SERVICE BULLETIN REVISION NOTICE

ENGINE — FUEL AND CONTROL — INTRODUCTION OF 33K BUMP RATING, MODIFICATION OF THE DATA ENTRY PLUG AND NEW ENGINE IDENTIFICATION PLATE

Turbojet Engine Service Bulletin No. V2500-ENG-73-0209 Revision No. 2 dated September 16, 2013.

ENGINE — FUEL AND CONTROL — INTRODUCTION OF 33K BUMP RATING, MODIFICATION
OF THE DATA ENTRY PLUG AND NEW ENGINE IDENTIFICATION PLATE

DATA ENTRY PLUG ASSEMBLY
Figure 1

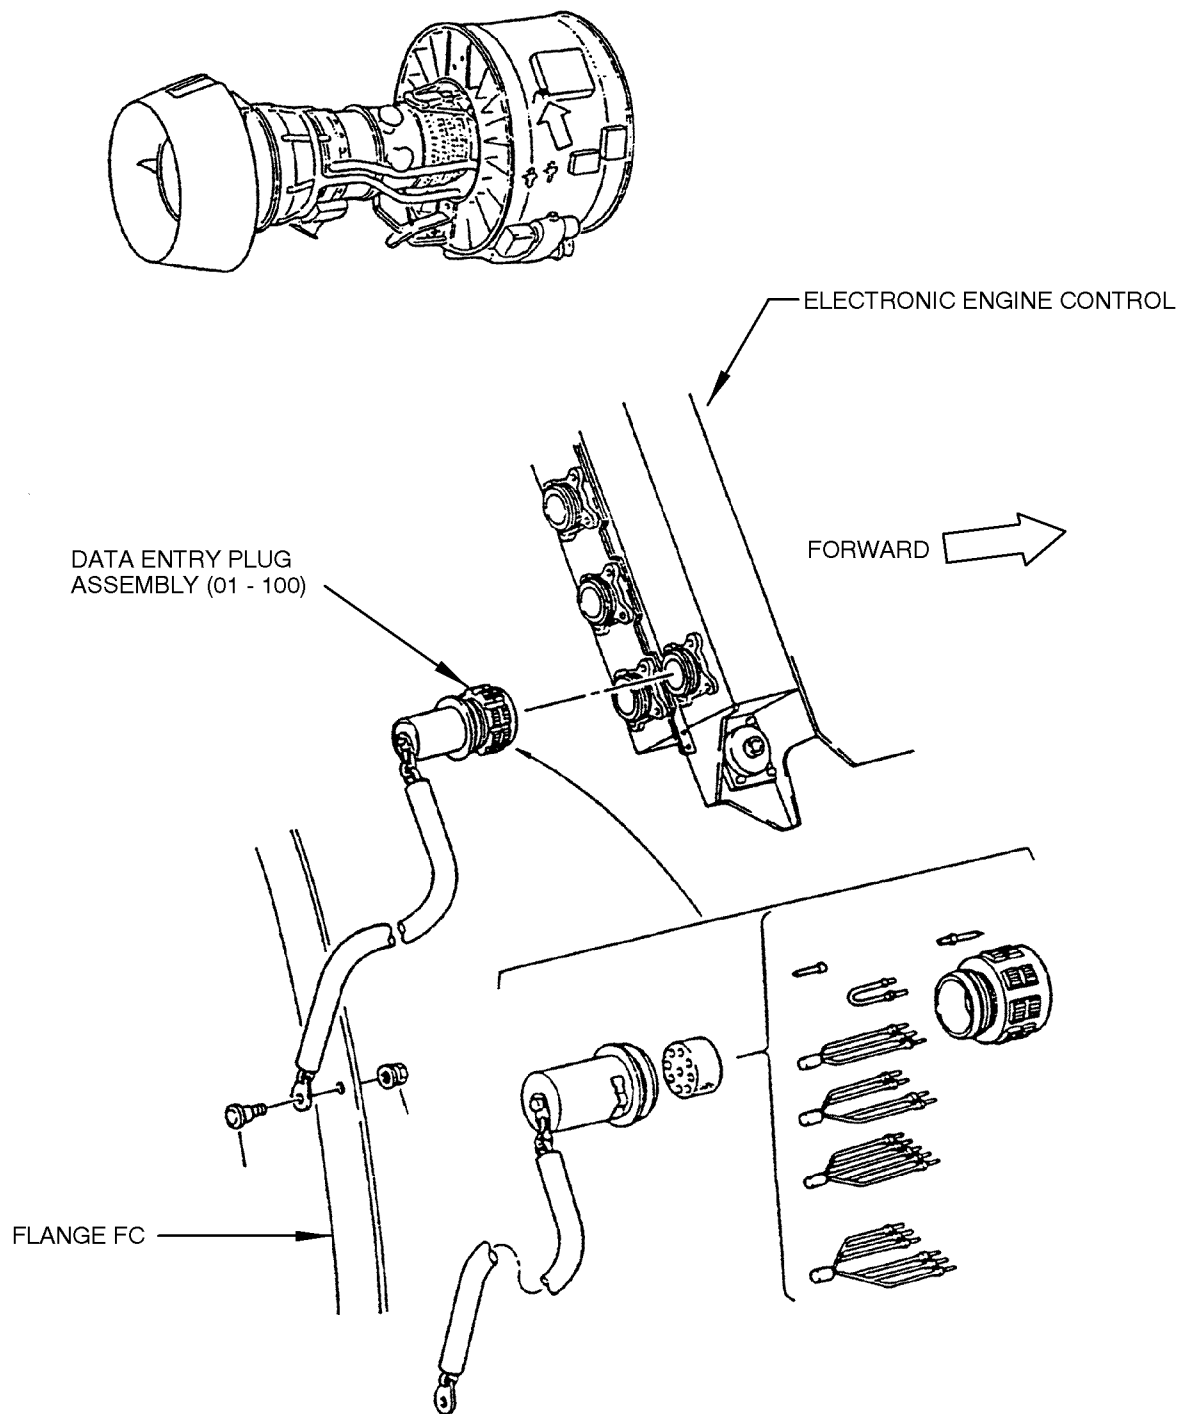
1. Remove the Data Entry Plug Assembly, PN 2A3106, (Reference 11, IPC Chapter/Section 73-22-35, Figure/Item No. 01-100) by the procedure given in Reference 10, AMM Chapter/Section 73-22-35, Repairs, VRS 3500.
2. Remove the backshell assembly to access the jumper wires by the procedures specified in Reference 10, AMM Chapter/Section 73-22-35, Repairs, VRS 3500 and Figure 1.

- F. Determine the jumper pin changes required from the differences between the diagrams in Figure 5A and 5B, and any new jumpers needed. See Figure 1 (taken from Reference 11, IPC, Chapter/Section 73-22-35, Figure/Item No. 01-100).
4. Modify the Data Entry Plug Connector by the procedure specified in Reference 10, AMM, Chapter/Section 73-22-35, Repairs.
5. Assemble the Data Entry Plug Assembly by the procedure specified in Reference 10, AMM, Chapter/Section 73-22-35, Repairs, VRS 3500 and Figure 1.
6. Do a check of the wiring, using electrical tester IAE 2P16369, by the procedure specified in Reference 10, AMM, Chapter/Section 73-22-35, Repairs VRS 3500.

IDENTIFICATION OF THE DATA ENTRY PLUG ASSEMBLY TO THE NEW PART NUMBER
Figure 2

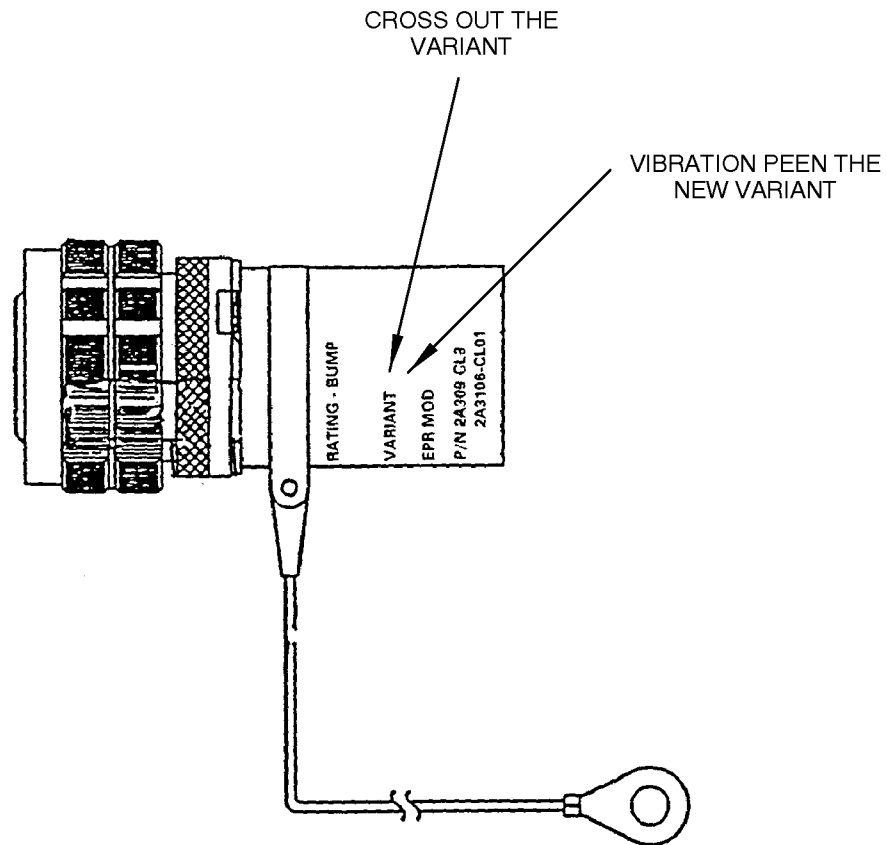
7. Mark the Data Entry Plug Backshell with the new Variant No. by the procedure given in Reference 12, SPPM, Chapter/Section 70-09-00, Marking of Parts and Figure 2. Use the vibration peen method.
8. Install the Data Entry Plug by the procedure given in Reference 10, AMM, Chapter/Section 73-22-35, Repairs, VRS 3500.
9. Replace the Engine Identification Plate. See Figure 4, Sheet 1.

ENGINE IDENTIFICATION PLATE — BEFORE AND AFTER ALTERATION
Figure 3

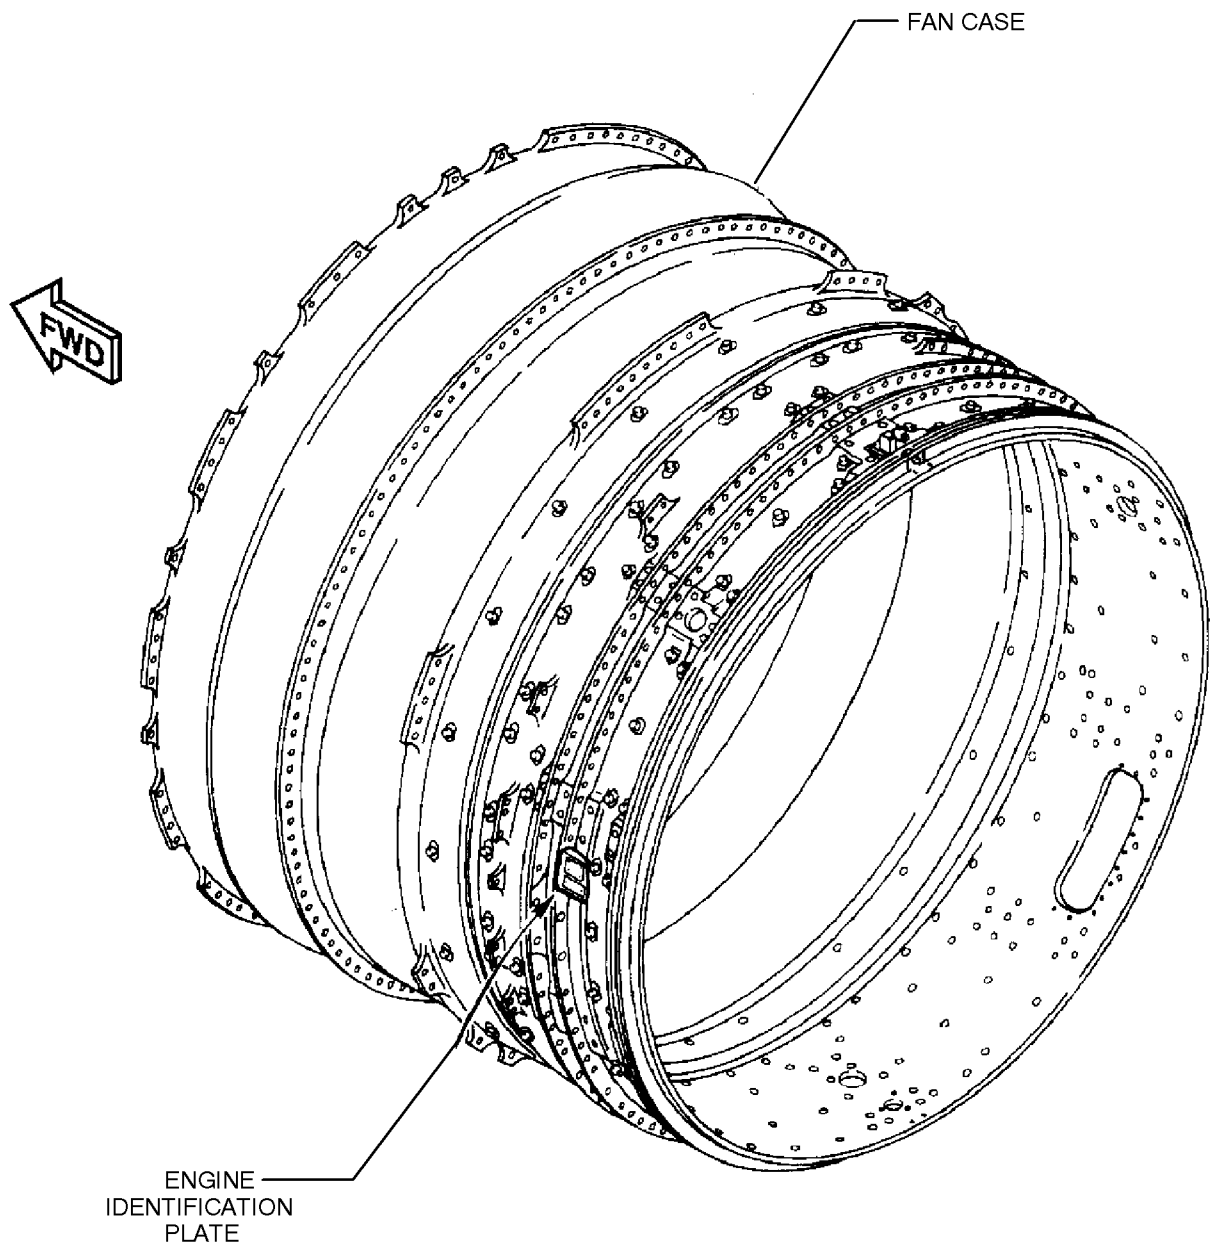
1. The changes introduced by this service bulletin are as follows:
 - A. New Engine Identification Plate has the blanks for marking of Data Entry Plug variant and Bump Rating in all 7 model fields required. See Figure 3. The new Engine Identification Plate, PN 5A1942 can be used on SelectOne™ engines or future Bump rated engines.
2. Existing Engine Identification Plate, PN 5A1875 can not be modified to new plate.
3. For relationship with other Service Bulletins, See References and Chart A.

- (5) Get the new Engine Identification Plate from your IAE Representative.
 - (6) Mark the Engine Identification Plate with the appropriate Take-Off Rating-Bump No. and Variant No. See Reference 12, SPP 70-09-00, Marking of Parts and Figure 3. Use the vibration peen method.

- (5) Mark the Engine Identification Plate with the appropriate Take-Off Rating-Bump No. and Variant No. See Reference 12, SPPM 70-09-00, Marking of Parts and Figure 3. Use the vibration peen method.

ENGINE IDENTIFICATION PLATE
Figure 4 (Sheet 2)

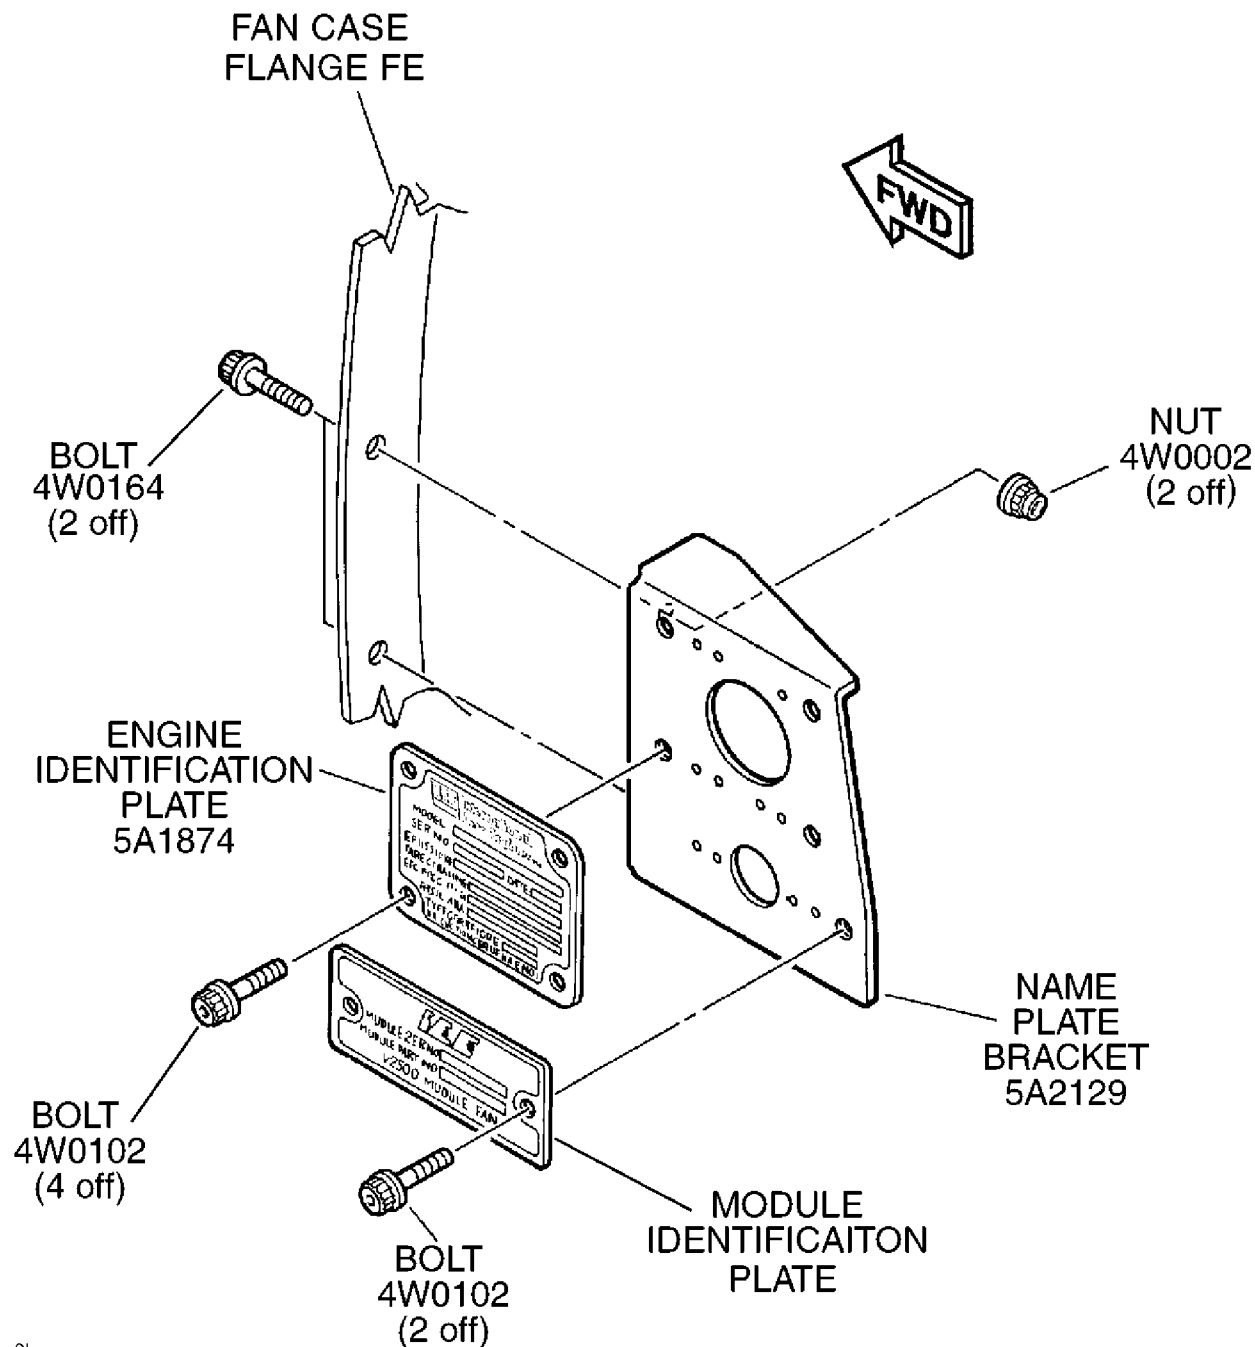
- A. If Engine Identification Plate (5A1874) is being replaced by the same Part Number Plate, see Figure 4, Sheet 2.
 - (1) Remove the four bolts (4W0102) and four nuts (4W0001), that hold the Engine Identification Plate to the Name Plate bracket.

- (5) Torque the 4W0102 Bolts between 36–45 lbf in (4.00–5.00 Nm) .
- B. If Engine Identification Plate (5A1874) is being replaced by Engine Identification Plate, PN 5A1942 see Figure 4, Sheet 2, Sheet 3 and Sheet 4.

ENGINE IDENTIFICATION PLATE
Figure 4 (Sheet 5)

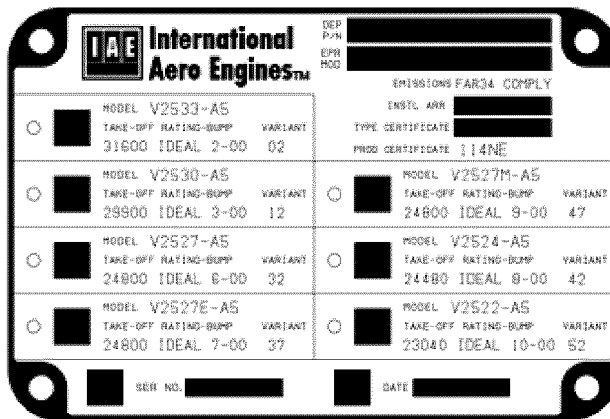
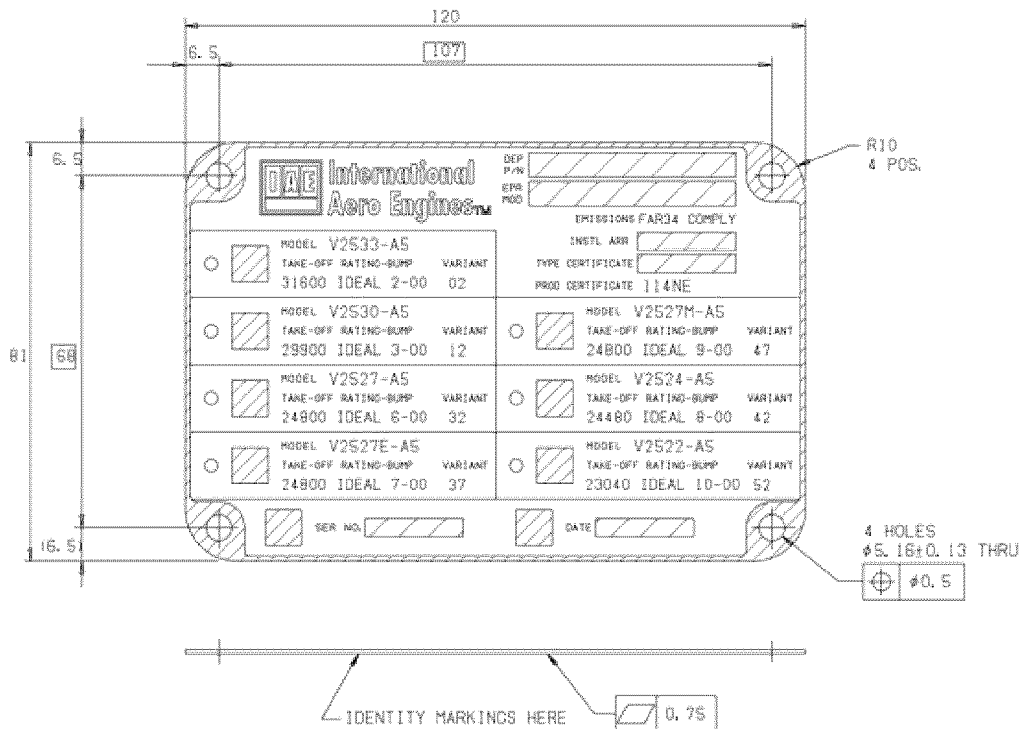
- (b) Install the Engine Rating Indicator through the Engine Identification Plate at the designated rating and squeeze with the power riveter. See Reference 12, SPPM 70-09-00, Marking of Parts and Figure 4, Sheet 5.

- (b) Install the Engine Rating Indicator through the Engine Identification Plate at the designated rating and squeeze with the power riveter. See Reference 12, SPPM 70-09-00, Marking of Parts and Figure 4, Sheet 5.

CONTACT HOLE LOCATIONS
Figure 5

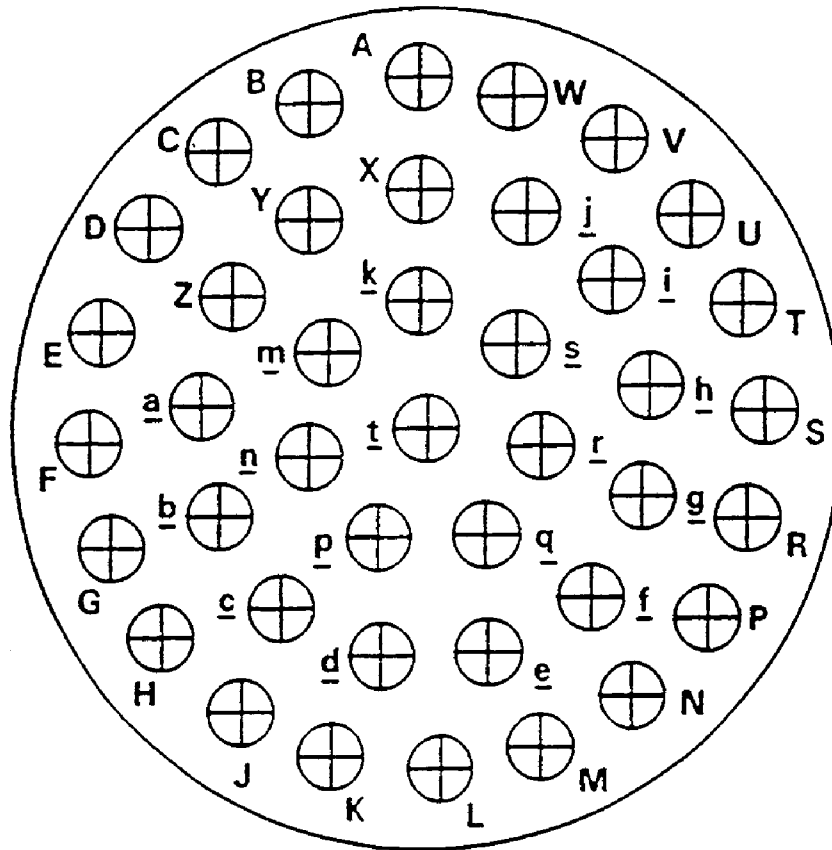
3. Make two copies of Figure 5, Contact Hole Locations. Mark one as 5A and one as 5B.
 - A. Record the following information in the corresponding fields on Figure 5A from the Data Entry Plug Connector:
 - (1) Engine Serial Number
 - (2) Bump Rating
 - (3) Variant
 - (4) EPR Modifier
 - B. Mark the existing Data Entry Plug connections on the diagram in Figure 5A.

NOTE: Jumper wires are utilized for the Variant, Engine Serial Number and EPR Modifier. Only the jumpers for the Variant require removal. The other connections need to be maintained per steps C through F below.
 - C. Locate the current variant number in Table 1. Highlight the pin connections listed in this table for the current variant number on the connections that were marked in Step B.
 - D. Using the same table from Step C, locate the variant of the desired new engine thrust rating. Mark these pin connections on the diagram in Figure 5B.
 - E. Now ignore the highlighted variant connections in Figure 5A, and copy the rest of the connections to the diagram in Figure 5B.

MCDU INTERROGATION OF EEC CONFIGURATION
Figure 6

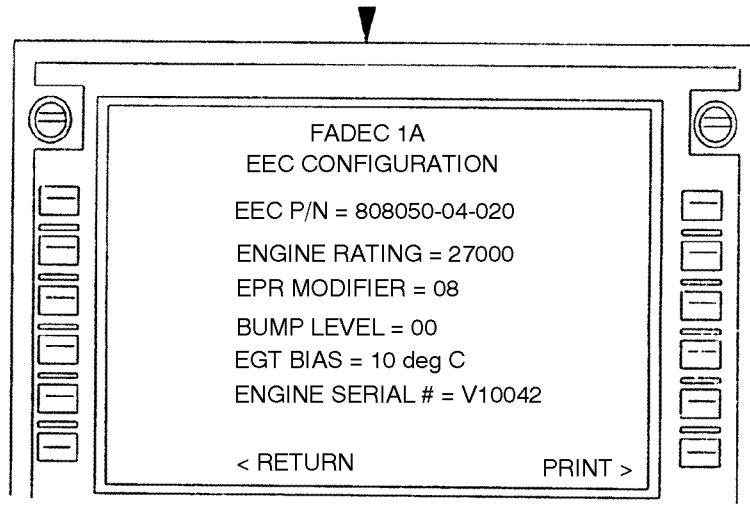
- (b) Torque the Nuts between 36 – 45 lbf.in. (4.0 – 5.0 Nm.).
- 10. Check the data entry plug wiring by interrogating the MCDU and comparing the output EEC CONFIGURATION information output to the Data Plate information, when the EEC

and DEP are installed on the aircraft. Use the procedure specified in Reference 10, AMM Chapter/Section 73-22-35, Installation and Figure 6.

NOTE: If this does not agree, the Data Entry Plug must be corrected or replaced; until then the aircraft can not be dispatched.
